A12 Chelmsford to A120 widening scheme

TR010060

9.37 Applicant's Comments on Essex County Council's Local Impact Report

March 2023

Junction 21 (Essex consultation response)

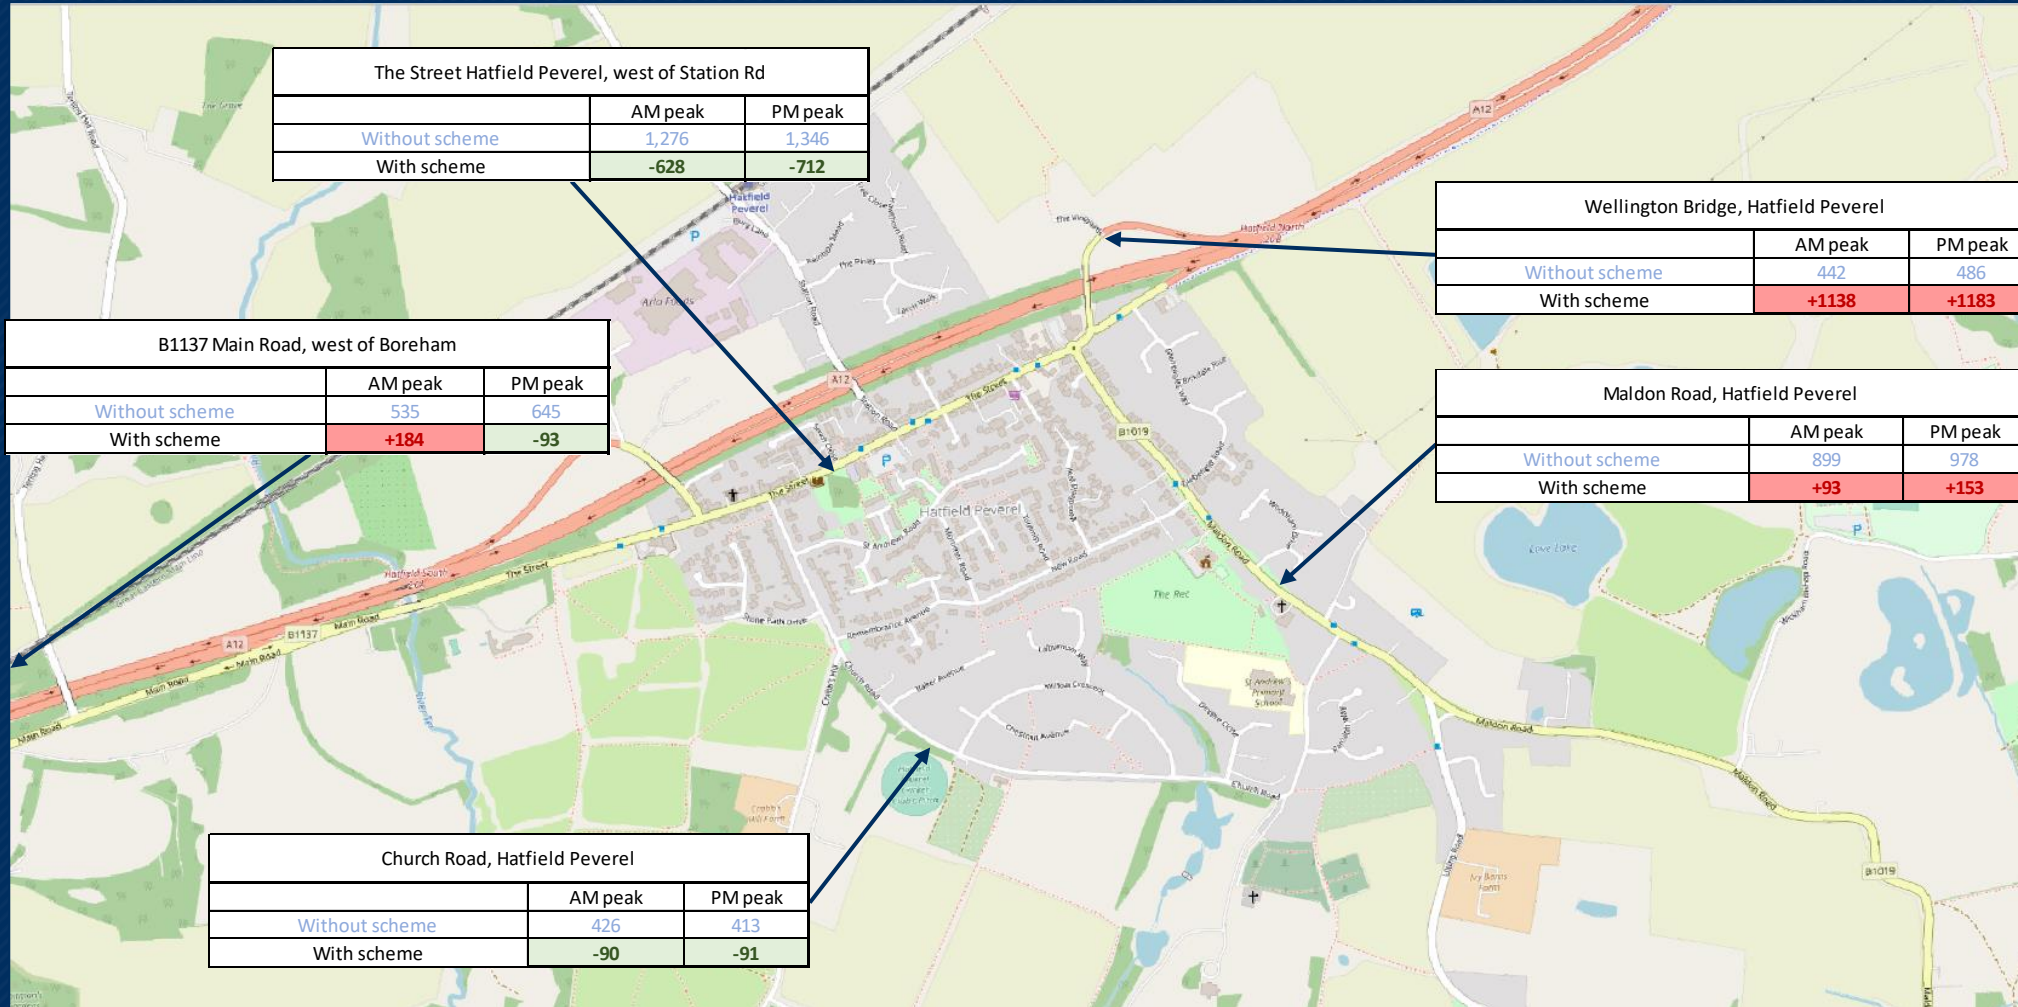
Traffic flow information for Church Road in Hatfield Peverel has not been provided, but there is a strong possibility that traffic from the B1019 Maldon Road could be using Church Road to access Main Road Boreham, rather than queue at the Duke of Wellington junction to access the new Junction 21.

This would add to the case for the B1019 Link Road, which would enable drivers from Maldon to access Junction 21 without having to get stuck in long delays at the Duke of Wellington junction. There is a reduction in traffic predicted on The Street, in-between Maldon Road and Church Road.
